ORIGINATION FORM

Proposed Revisions to a Standard Plans Index (Please provide all information – Incomplete forms will be returned)

Contact Information:	Standard Plans:
Date: July 31, 2019	Index Number: 536-002
Originator: Richard Stepp	Sheet Number (s): 1,2,3,27,28
Phone: (850) 414-4313	Index Title: Guardrail Transitions and Connections for
Email: richard.stepp@dot.state.fl.us	Existing Bridges
Summary of the changes:	
Instead, this Index will provide new trailing end transi Sheet 2: removed Detail K references in details (typo terminals from flared to parallel Sheet 3; Visually changed approach terminals from fla	from old Standard version); Visually changed approach ared to parallel etail title to sync with Pay Item title, "Guardrail Approach
Commentary / Background:	
Added Trailing End Transition Connection to Rigid Barits own Pay Item.	rier details for Existing Bridges on new Sheet 28. This will have
Other Affected Offices / Documents:	(Provide name of responsible personnel)
Yes No Other Standard Plans —	
FDOT Design Manual –

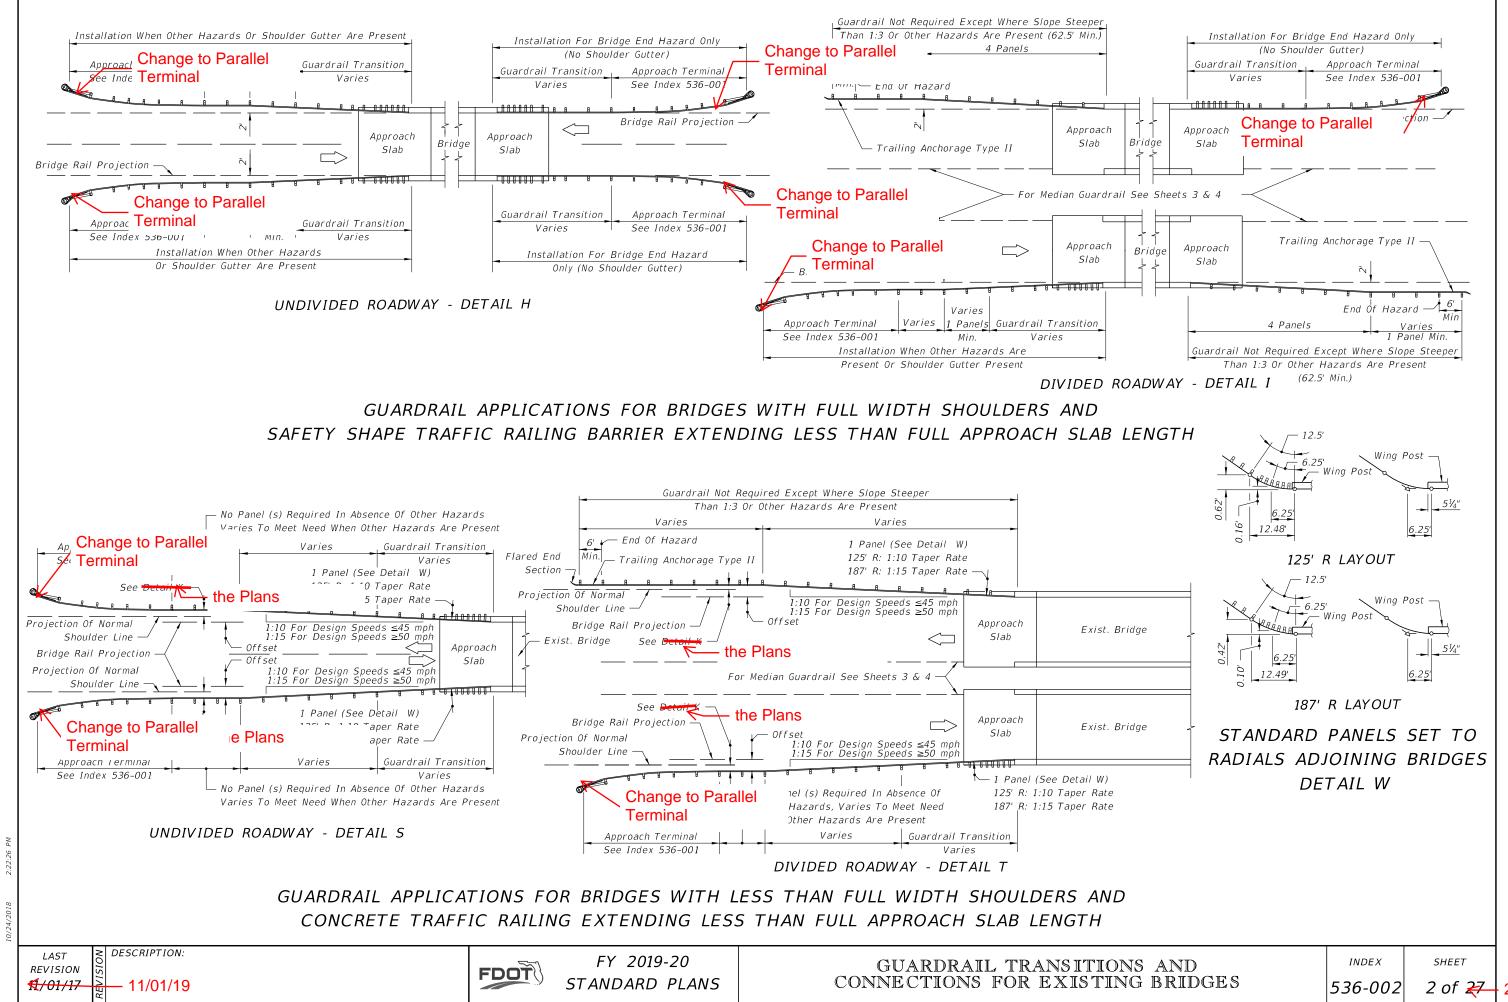
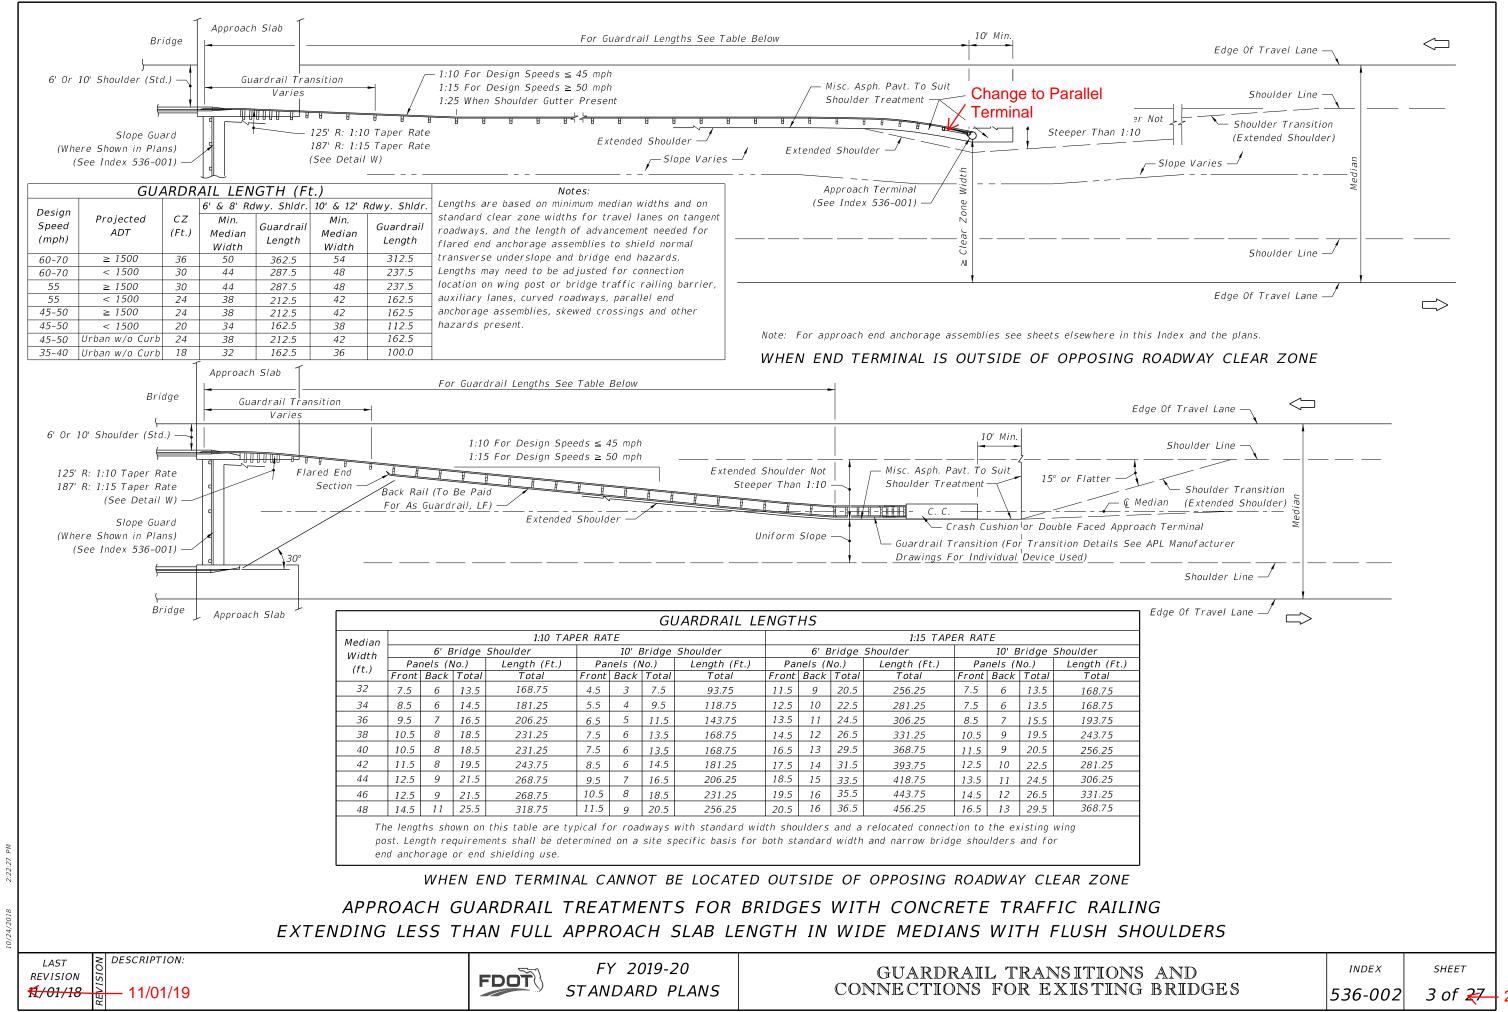
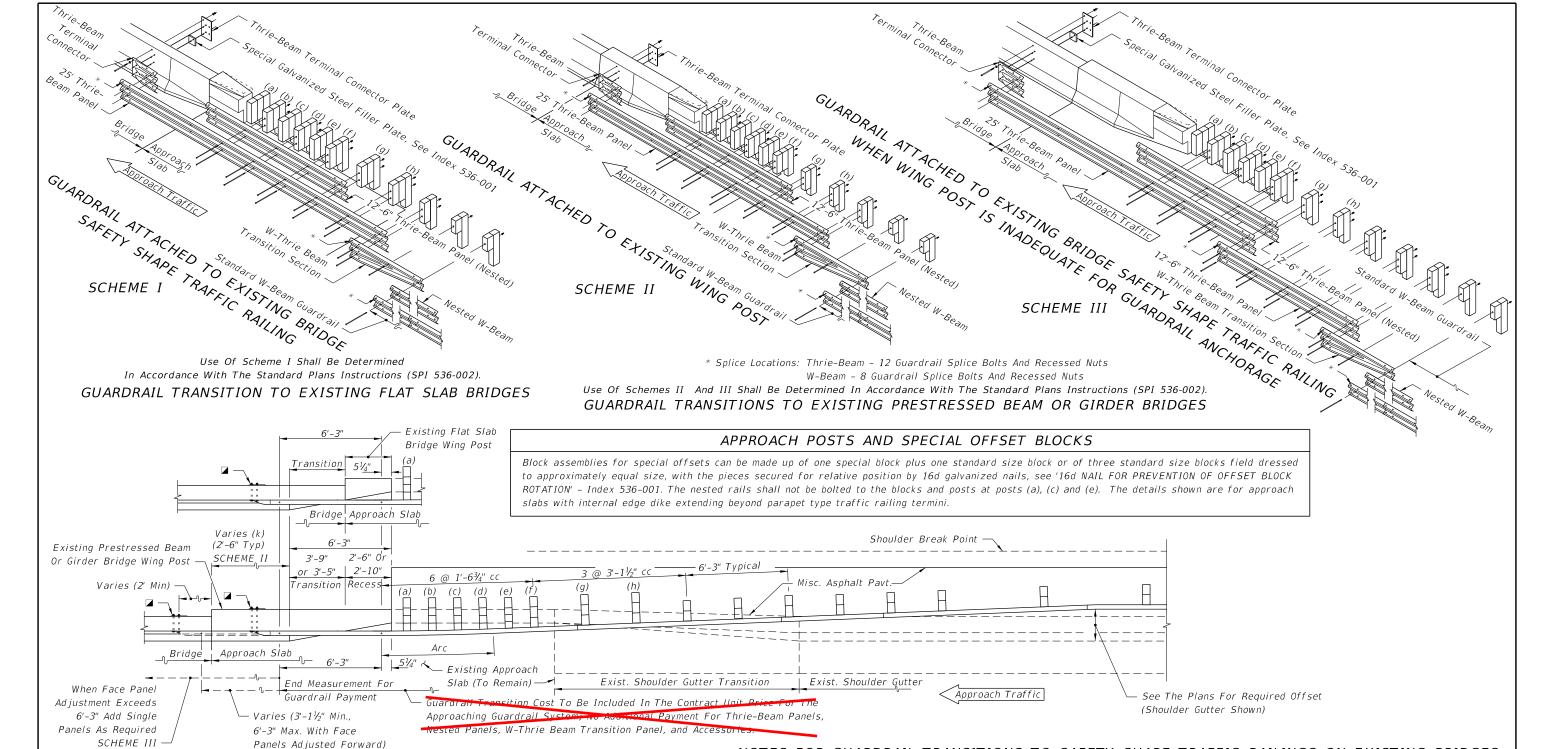
Removed reference to Trailing End Transition Connection to Rigid Barrier in 536-001. Instead, a new detail is on new Sheet 28 of this Index.
